Reference: Amherst Island Wind Energy Project (“Project”)
MOE reference # 1271-96VNH3

Further to the discussion held with Ms. Sue Edwards with respect to the Amherst Island Wind Energy Project (“Project”), Algonquin Power Co. (on behalf of Windlectric Inc. – a subsidiary of Algonquin Power Co. (“Algonquin”)) below is a list of minor Project layout changes, constituting Administrative and Technical Changes as defined in Chapter 10 of the Renewable Energy Approval (REA) technical guide.

C. Please see Tab #1 for rough conceptual drawings of the proposed amendments.

Figure No.
1.1 **DRAFT**

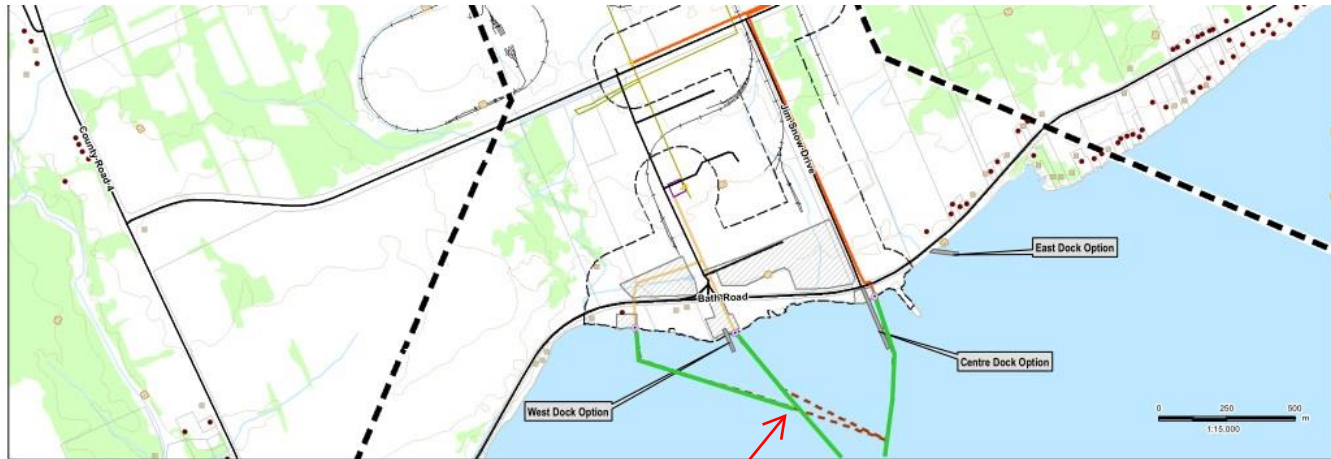
Cable Vault should be illustrated farther onto land as described in Design and Operation Report

overhead line angle changed: (a) no extra poles and (b) all poles in stage 2 ploughed area

adjust overhead line - remove two poles (at the bend)

Title
Project Location & Study Area

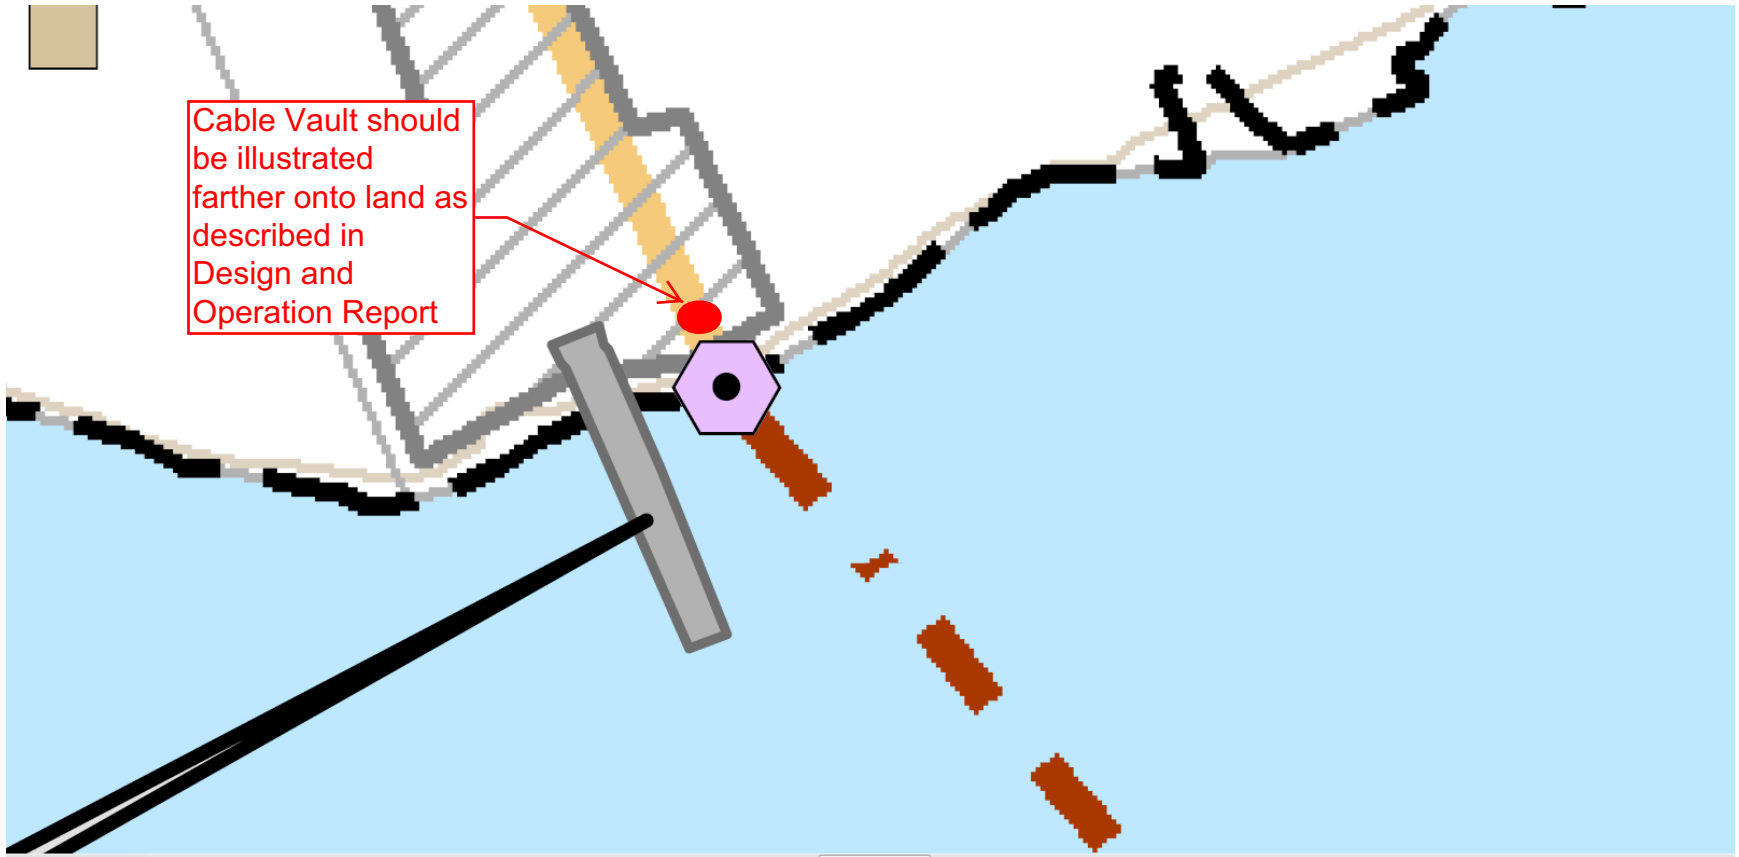
Proposed change
 to cable route to
 avoid Crown
 Lease easement

- The Project team has been completing further refinement of the submarine cable route, and has recommended the middle submarine cable landing area be routed (east of the west dock option) in order to provide greater assurance of avoiding the Crown Lease easement.

Amherst Island - 2-Barge Dock Concept Sketch

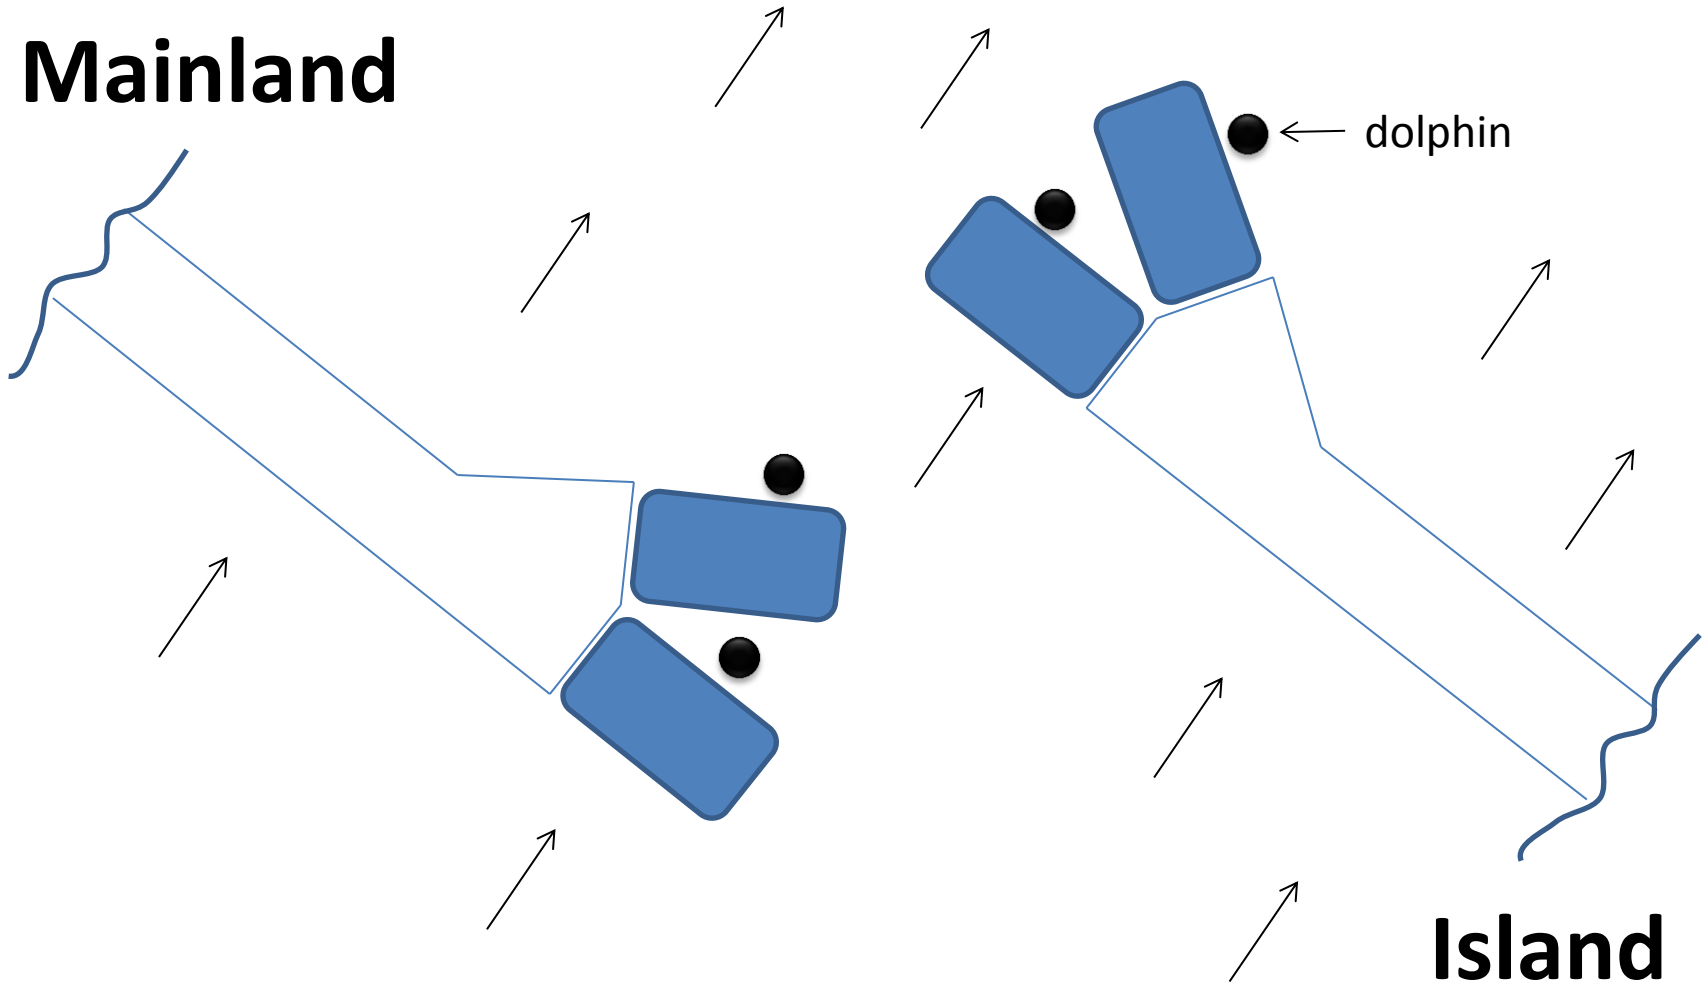
- To achieve the two barge docking design, the dock designs would need to be wider near the end, widening from 10m to approximately 15m over the last 10m of dock length.
